MM Knitwear Ltd

14 December 2013

Building Observations

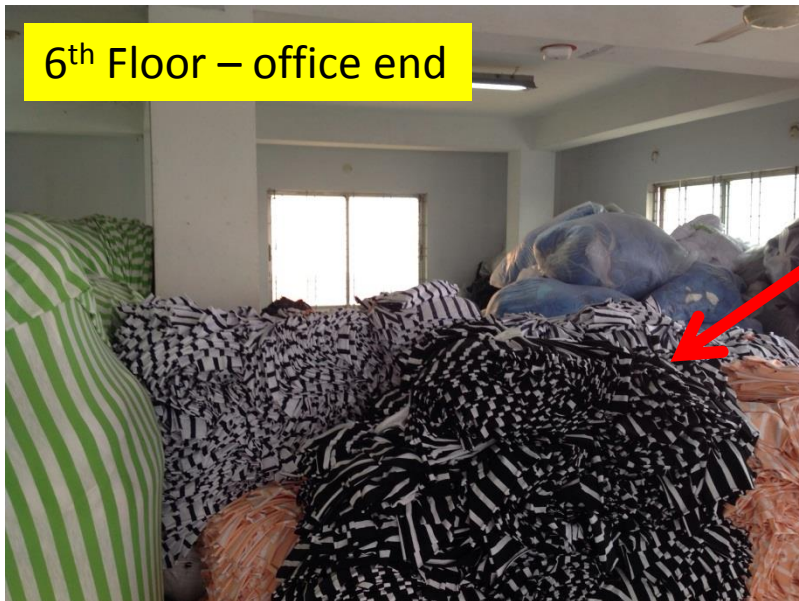
Limit density of loading in storage areas

Uncontrolled loading

Plan and height restrictions to be introduced to prevent future overloading. (Loading plans in line with design loads from engineer)

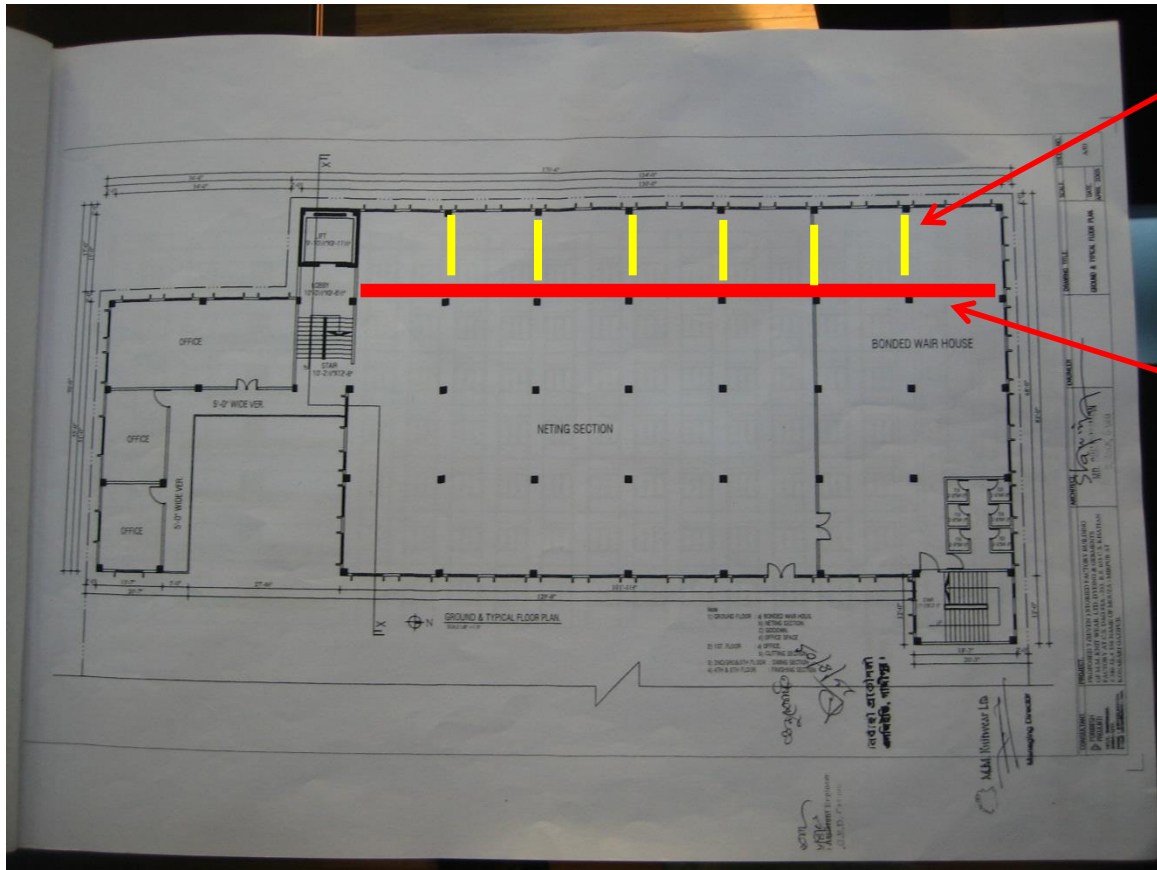
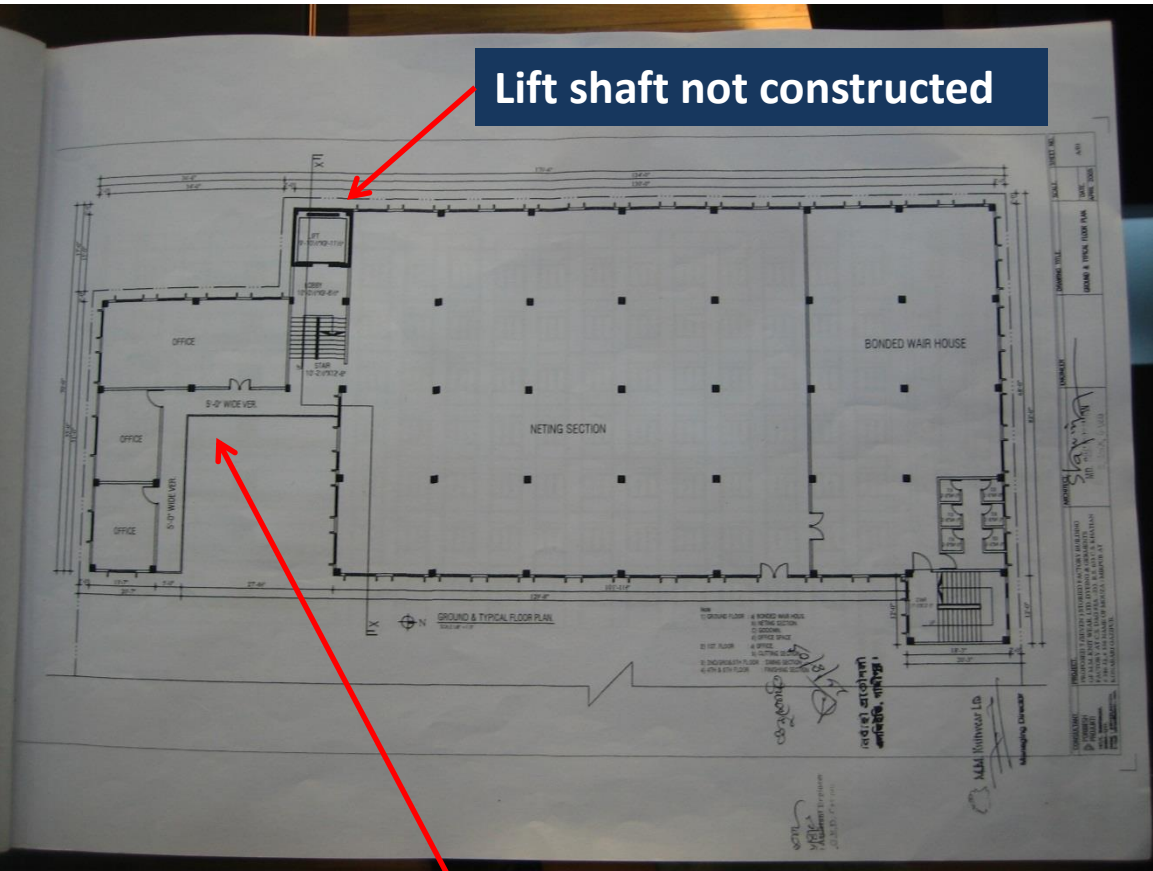
Drawings do not match constructed building

Beams here to underside of Level 1, 2 and 3

Beams here to all levels (original edge of building in Phase 1)

Structural engineering drawings do not match constructed building

Building 3 - Generally

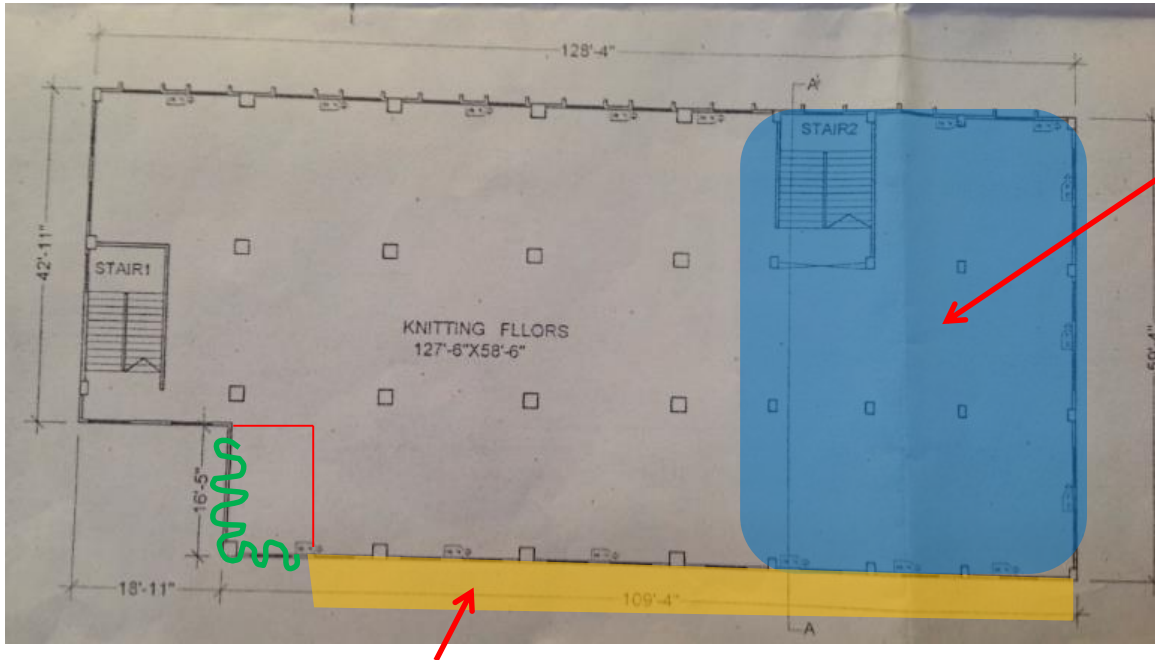
Drawings do not match constructed building

Columns in this area do not correspond with drawings (location or size)

Cantilever along this edge (Level Roof to Level 3) does not correspond with drawing. Also extended building edge to additional row of columns at Level 2 not shown

No structural engineering drawings available

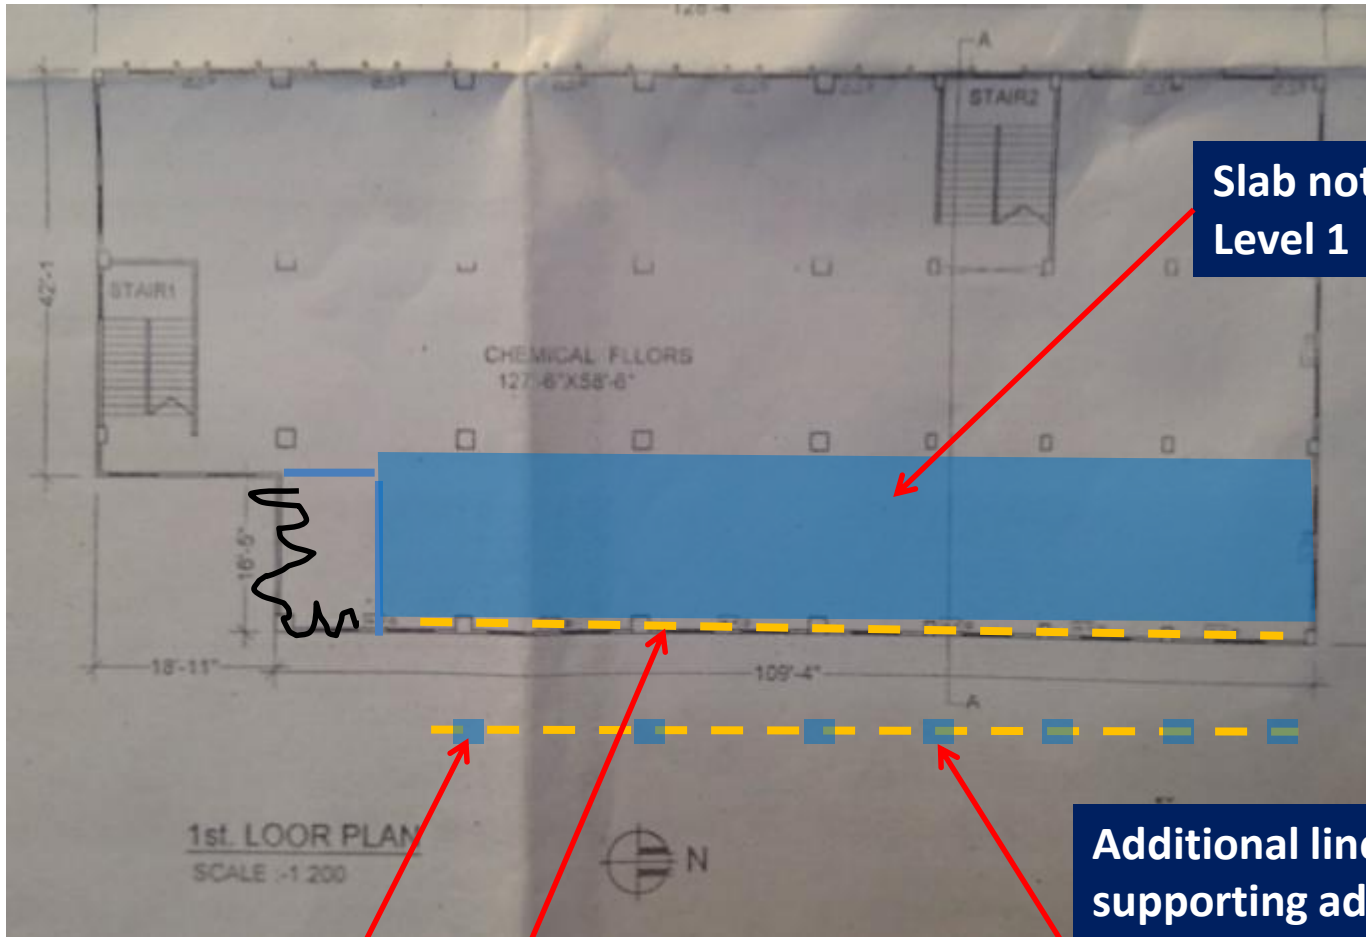
Drawings do not match as built

Slab not present here at Level 1

Additional line of columns supporting additional area of slab at Level 2 beyond cantilever area shown generally

Concern with restraint of columns at Level 1 – engineering check required

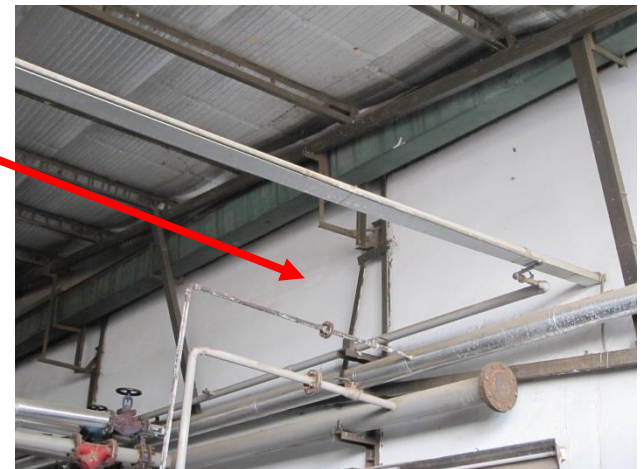
Support to roof purlins on damaged RC beam

Support to steel roof with wall brackets

Generally engineer to check lateral stability of shed roof structures and acceptability of supports throughout

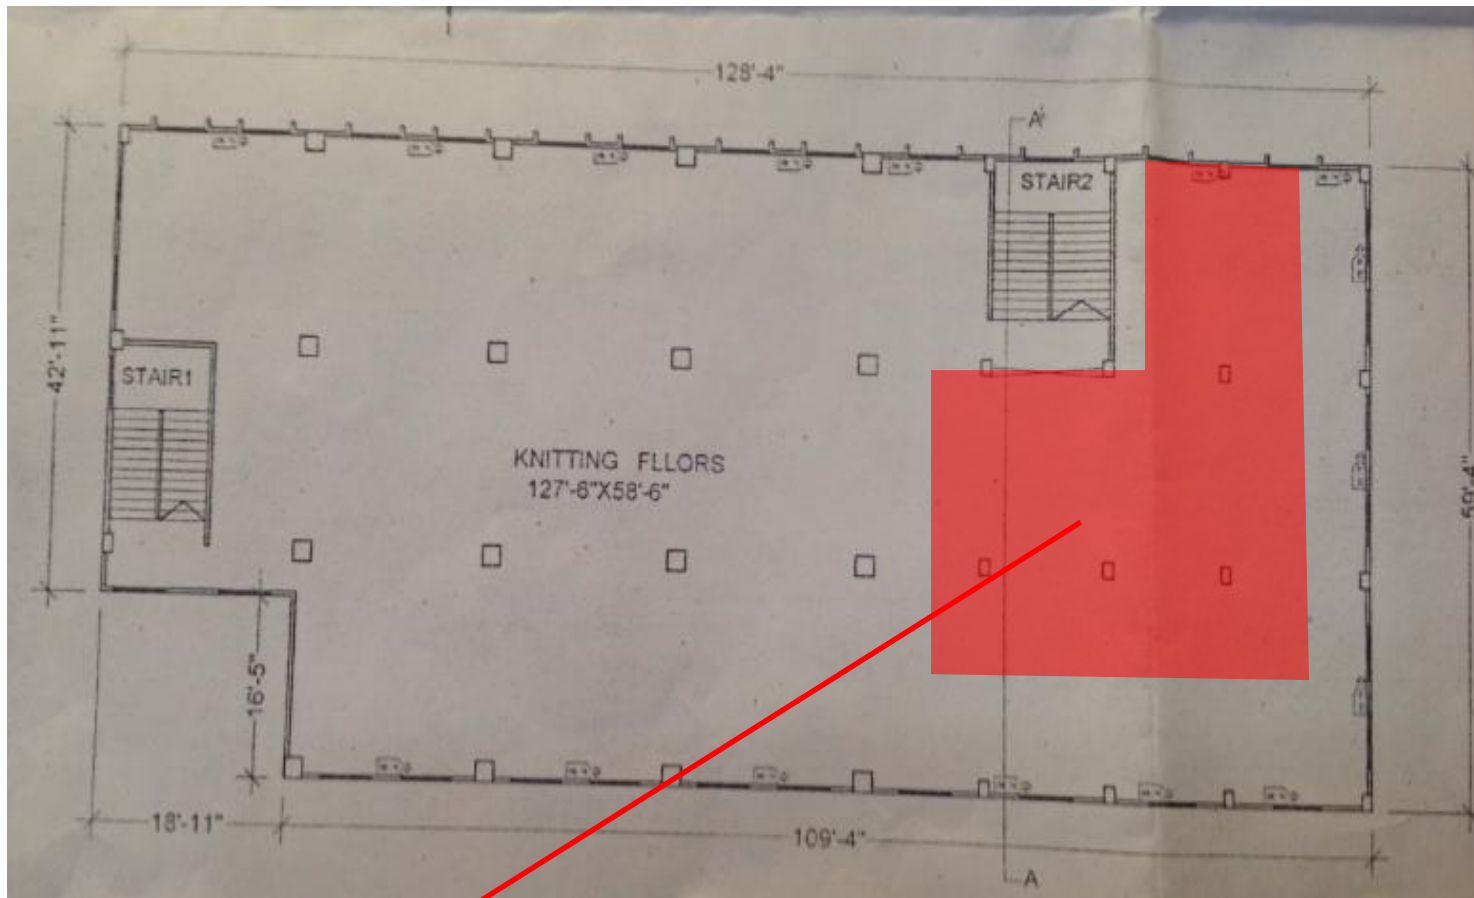
Storage in this area on any level (particularly level 2, 4 and 5) to be reduced to 1.5m high immediately
